# BEFORE THE MERIDIAN CITY COUNCIL

IN THE MATTER OF THE )	
REQUEST FOR FINAL PLAT	
CONSISTING OF 10 BUILDING	<b>CASE NO. FP-2025-0026</b>
LOTS AND 6 COMMON LOTS ON	
7.91 ACRES OF LAND IN THE R-2	ORDER OF CONDITIONAL
AND R-4 ZONING DISTRICTS FOR )	APPROVAL OF FINAL PLAT
MONDT MEADOWS SUBDIVISION )	
)	
BY: GREGG DAVIS, BRECKON )	
LAND DESIGN	
APPLICANT )	
)

SUBJECT: FP-2025-0026

Mondt Meadows Subdivision - FP

# D. Final Plat (date: 11/13/2025)

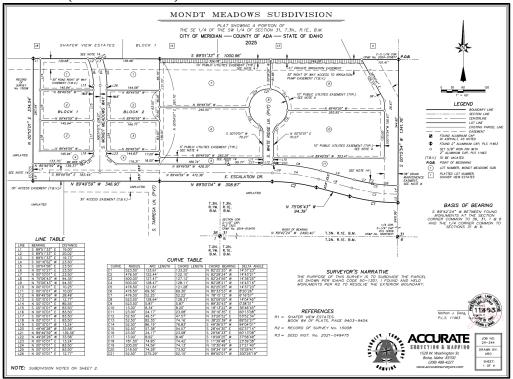
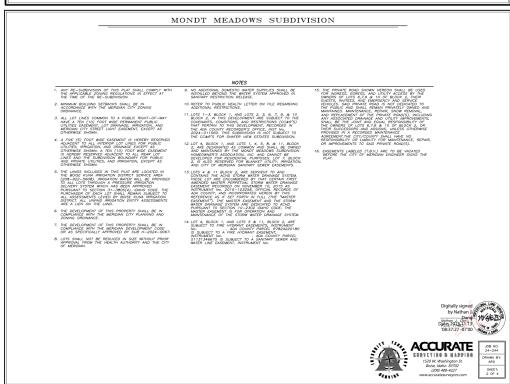
- 3. The final plat shown in Section V.B, prepared by Accurate Surveying & Mapping, stamped on 10/21/2025 by Nathan J. Dang, PLS, shall be revised prior to signature on the final plat by the City Engineer, as follows:

- a. Note #14: Include the instrument number for the water and sewer easements.
  - b. Add the recorded instrument number for any ACHD permanent easements.

- c. Add the recorded instrument number for any ACHD license agreements.
  - d. Add the recorded instrument number any City of Meridian sewer and water easements.

- e. The 30-foot easement on the north property boundary shall be vacated prior to the City Engineer's signature and the depiction of the easement removed from the plat, including the deletion of note 16 on sheet 2 of 4.

# G. Amenities Exhibit

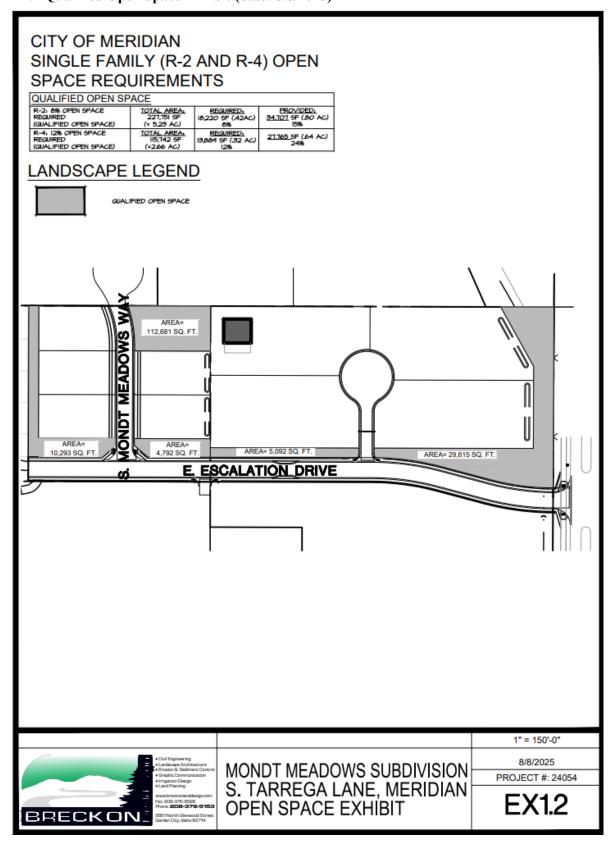
- 4. The landscape plan prepared by Jon Breckon stamped on 9/17/2025, is approved.
- 5. The Open Space amenities as shown in Exhibit VI.G shall meet the following requirements: the picnic area shall include tables, benches, landscaping, and a structure for shade; and the outdoor fire ring shall meet fire safety standards, is located on a noncombustible surface and includes fixed seating.
